Date of Issuance: 03/08/2024	Effective Date: 09/14/2023
Owner: Town of Pendelton	Owner's Contract No.: #219091-21-049G
Contractor: Sicoli Construction Services, Inc.	Contractor's Project No.:
Engineer: Nussbaumer & Clarke, Inc	Engineer's Project No.: 22J1-0123
Project: Town of Pendelton Community Center	Contract Name: General Construction Contract

Attachments: *Change Request #12 - Bollards in front of Gas Meter*

CR #12 - Bollards at Gas Meter

Contractor's RFI No. 5 Date: 2/23/2024
RFI Title: Bollards at Gas Service
Job No.: 22J1-0123

LDPE/HDPE TYPICAL BOLLARD

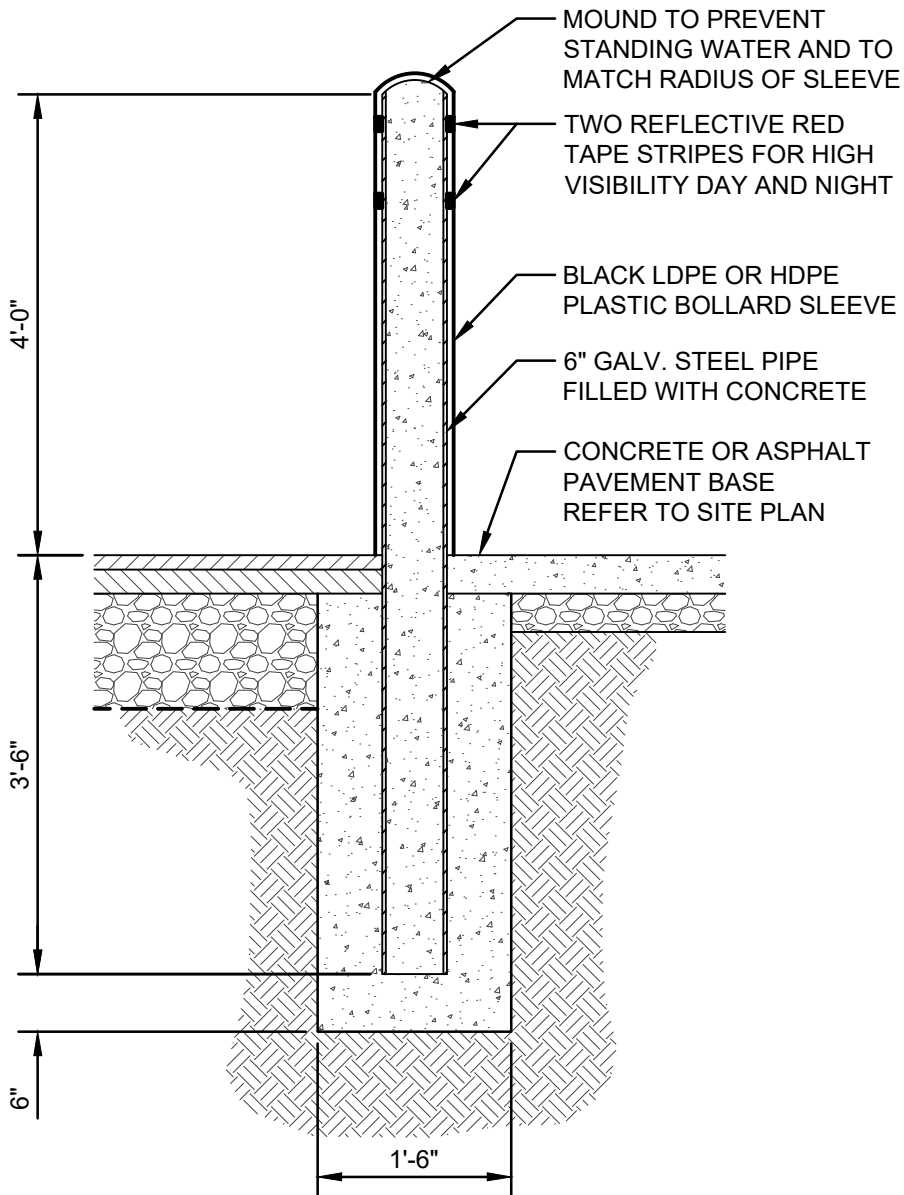
Ron from the Town of Pendleton Code Enforcement informed us that Bollards are required to be installed in front of gas service at the Building. There is nothing indicated in the Documents to do so. Please advise

Contractor to install 2 Bollards in front of the new Gas Meter per the attached Detail.

1. LDPE OR HDPE PIPE BOLLARD COVER WITH ROUNDED TOP, 1/4" THICK WITH INTEGRAL COLOR AND ADHESIVE/TAPE SYSTEM TO ANCHOR COVER TO BOLLARD.
